## تعدیل شماره 2

Project: Procurement of Design, Supply, Installation, Test and Commissioning of 220/20kV, 16MVA at Dasht-e-Archi Substation and extension of line Bay 220KV at Asqalan Substation, Kunduz Province with Ref.No: NPD/DABS/1403/NCB/W-1154

Procurement Entity: Da Afghanistan Breshna Sherkat – DABS

Date: April 22, 2025

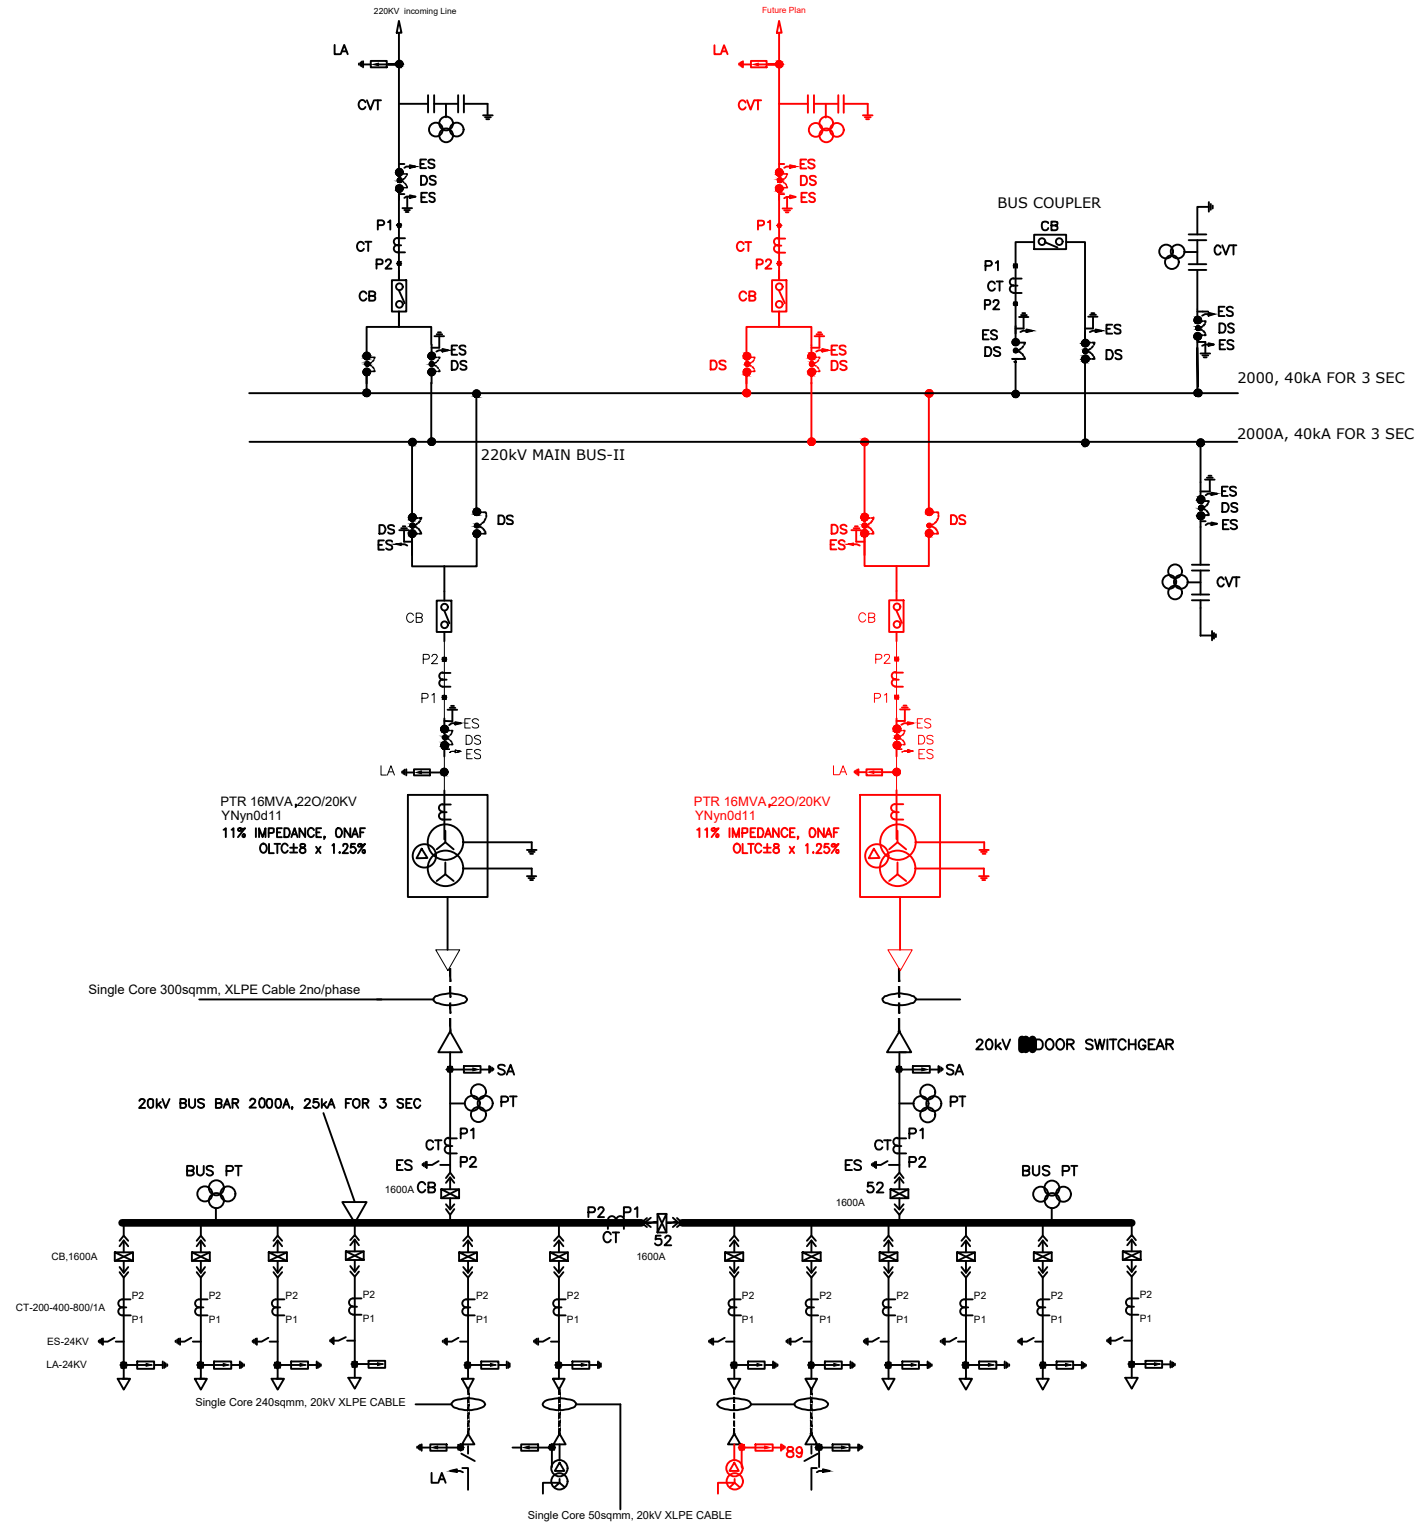
<ul style="list-style-type: none"> <li>Disconnect switch in Bus Coupler: in BOQ it is noted only one set disconnect but in <u>drawing, Annexure No.2</u> shown two set of disconnectors, please clear this item. In case of changing in BOQ please share revised files with us.</li> </ul>	
10	<b>Busbar Protection for Dasht-E-Archi SS:</b> In requirement of project not mentioned, that which type of high or low impedance should be consider for this project. Please clear this item.	the High Voltage (HV) Current Transformers (CTs) should be supplied and installed in accordance with the specifications, the Contractor should consider in design one Core for Busbar protection syetem. In decision, decided to proceed the system without integrating the bus bar protection system at this stage for future it will install.
11	<b>Capacity of Batteries:</b> As checked requirement, the total Capacity (AH) is not specified, please share your feedback in this regard.	Contractor responsible for design and Calculation of Capacity of batteries (AH), as per requirement of Substation.

13	<b>Busbar Type of Dasht-E-Archi Substation:</b> As checked drawings and requirement of project, the project scope is double busbar system as will the SLD is showing accordingly, but the <u>drawing, Annexure No.2 page 6</u> in layout drawing shows different configuration for busbar simulating 4 busbars. In this case it will cause huge extra cost for steel gantry structure, Busbar conductor, Hardware fittings, insulators and related materials. While normally like this scope need construction of only two busbars. Please clarify this item which has very huge cost difference on electrical and civil material costs.	<u>Annexure No.2 page 6</u> in layout drawing is Concept, As per Technical specification B0.1 Page (8) contractor could provide detail design for double Busbare arrangement.
14	<b>Interfacing SCADA System in Asqalan Substation Extension:</b> As the scope in Asqalan substation is only 220KV line Extension and checked BOQ, in item	As per the current scope, the extension in Asqalan Substation involves only the addition of a 220kV line bay. The mentioned BOQ item includes the "Supply of
